ADDENDUM NO. 1

April 18, 2017

TO THE CONTRACT DOCUMENTS FOR
PIEDMONT HILLS HIGH SCHOOL
Building D Science & Classroom Buildings
for the
EAST SIDE UNION HIGH SCHOOL DISTRICT

DSA # 01-116180 - FILE NO. 43-H10

CAMPUS SITE PLAN

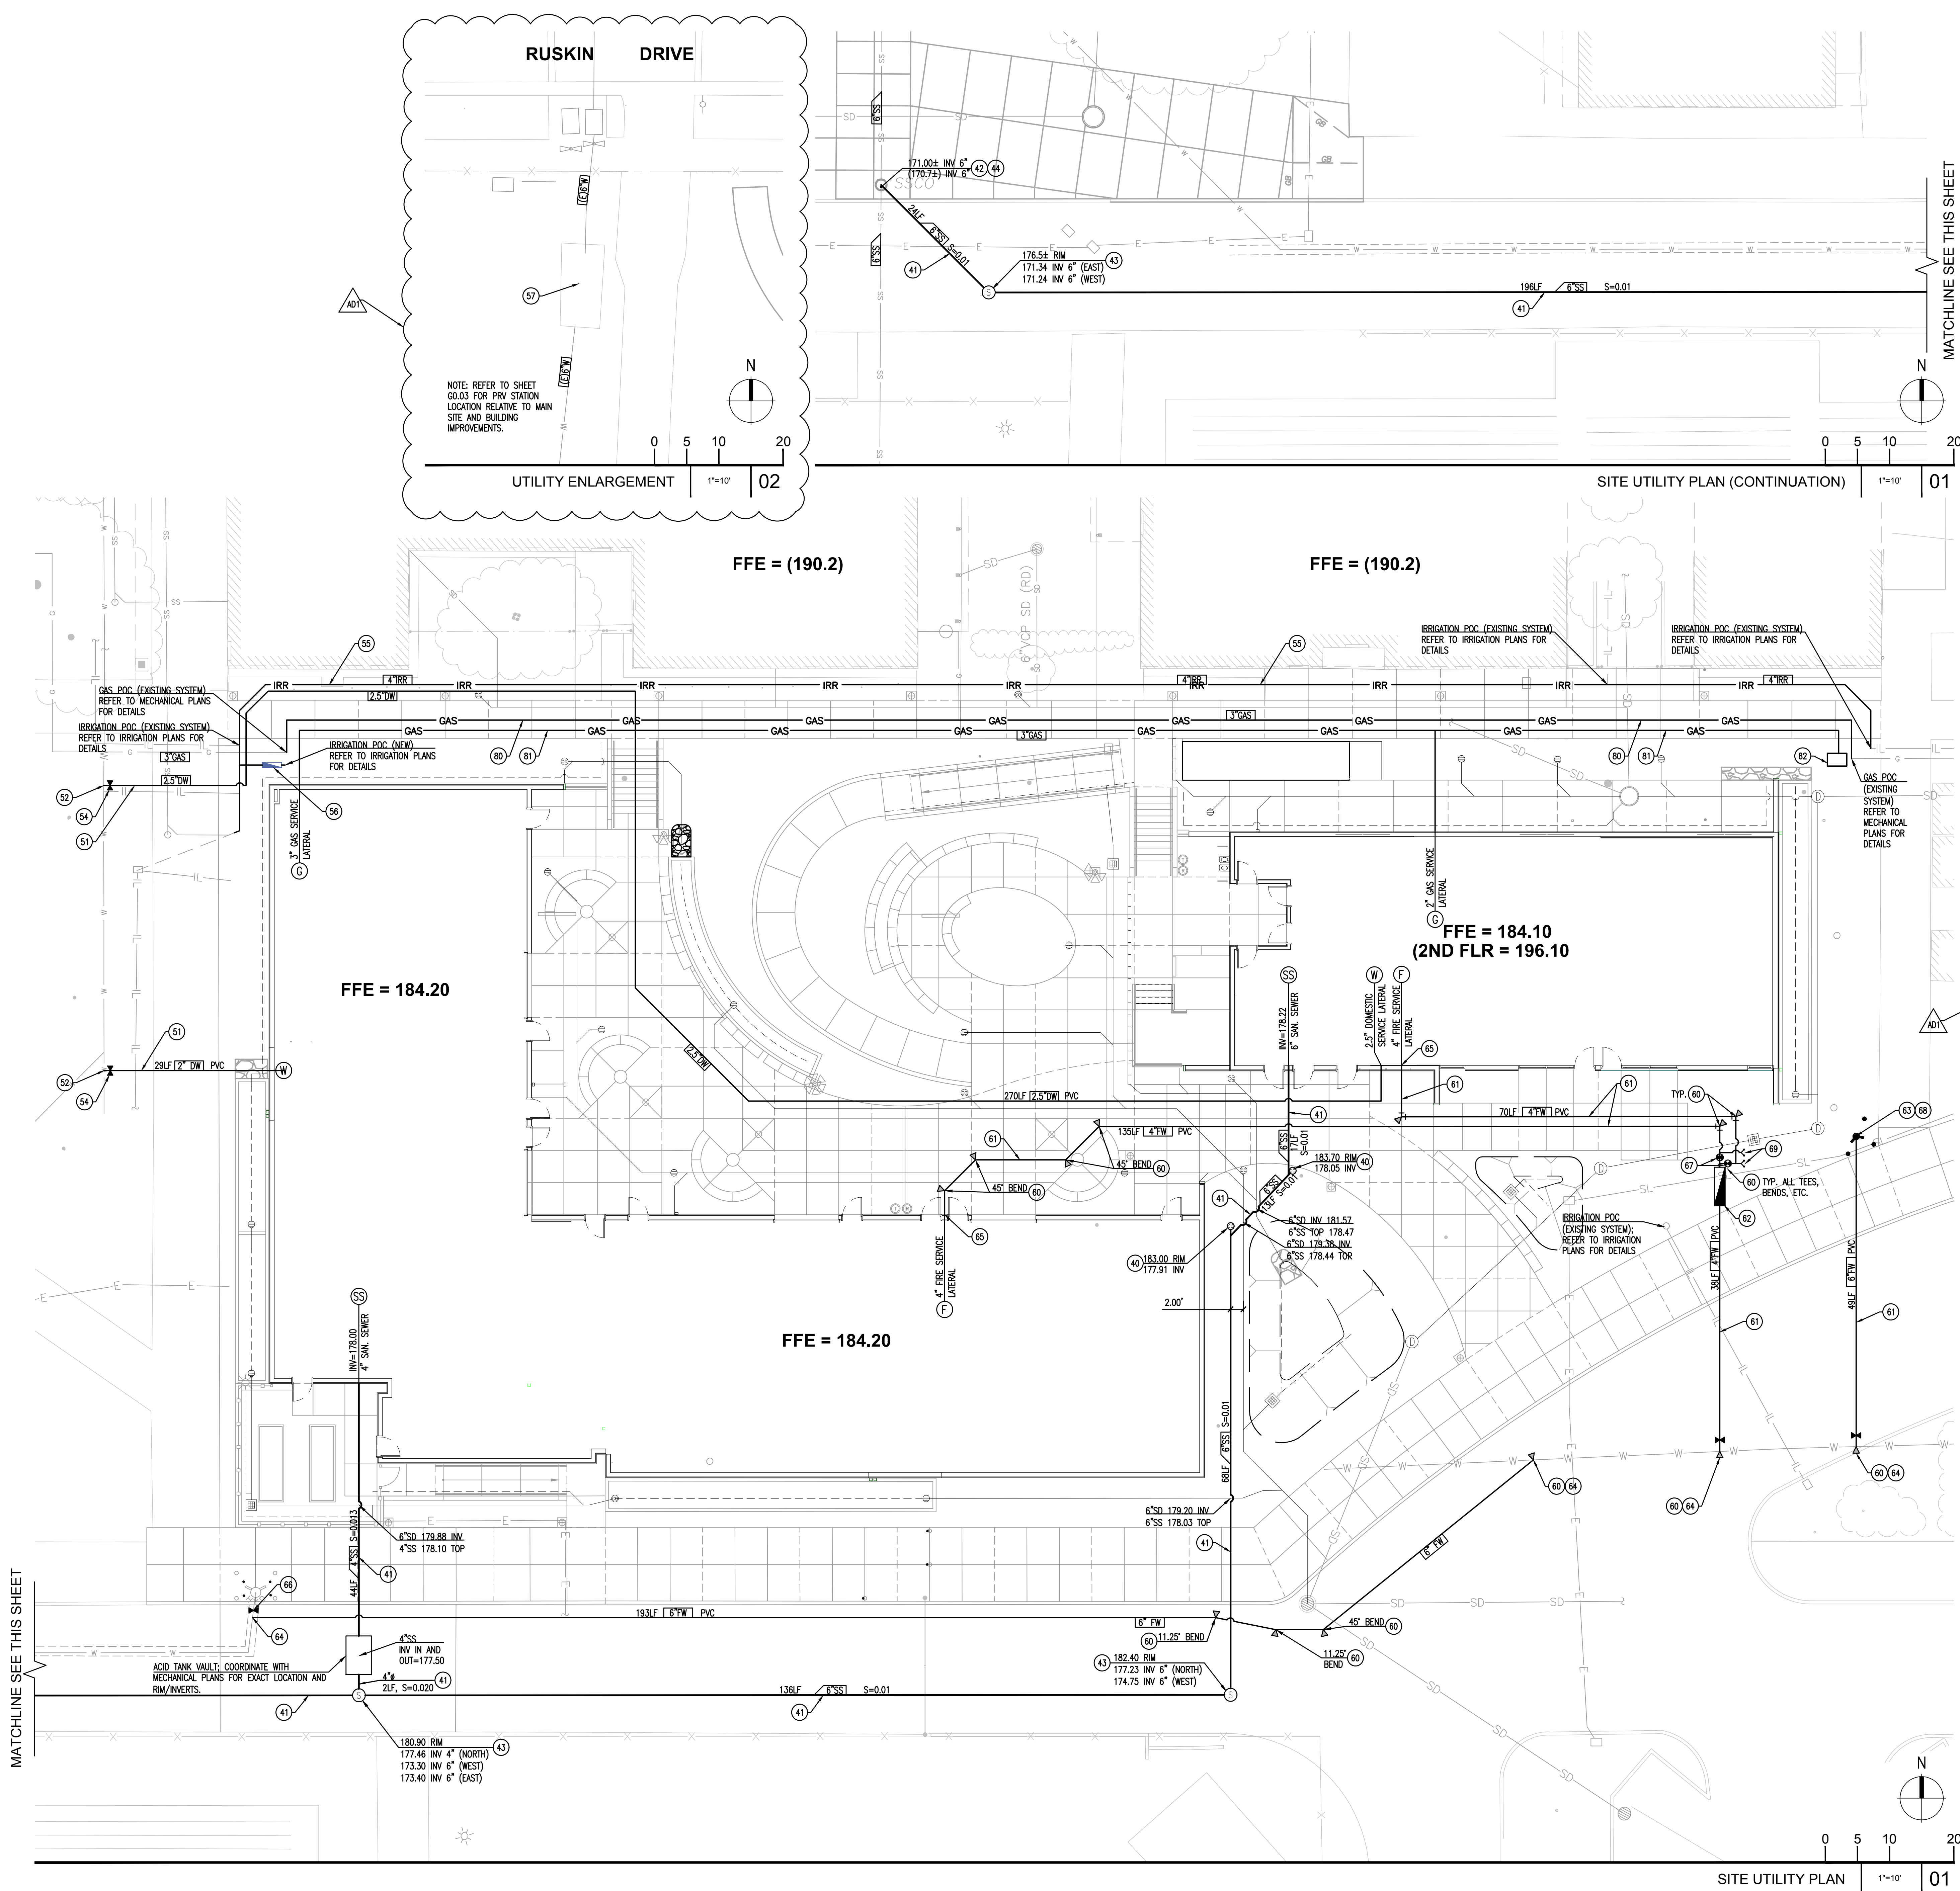
ITEM NO. AD1 -06 Delete sheet G0.3, Campus Site Plan. Replace with sheet G0.3, Campus Site Plan

- a) Remove and replace (E) PRV at Ruskin Drive side of campus.
- b) Refer to PRV detail 1/Civil C5.03
